Product Change Notice

PCN Ref Nº: PT-6 and PS-6 marking improvement

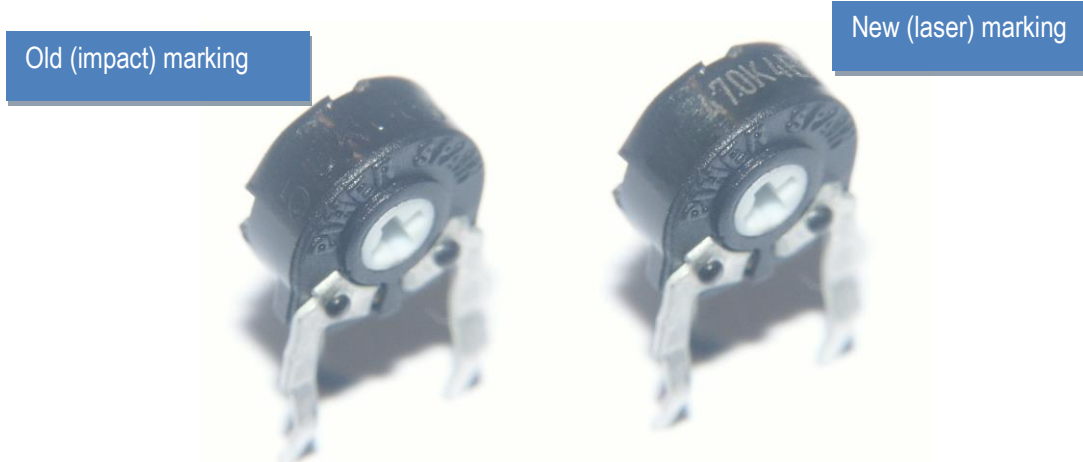
The new laser marking used in the PT-6 and PS-6 products not only allows more contrast and clear letters but a higher quantity of characters to be printed too.

While impact marking only allowed seven digits max., now we can print up to ten digits thus providing more valuable information.

Please be informed that we are upgrading the PT-6 and PS-6 marking pattern to match the scheme used in PT-10 and PT-15 family.

Old marking: Value, year, month, week, opcional E for long life (**Max. 7 digits**)
Example *100K2H2*

New marking: Value, year, week, tolerance, opcional E for long life (**Max. 10 digits**)
Example *100K427ME*
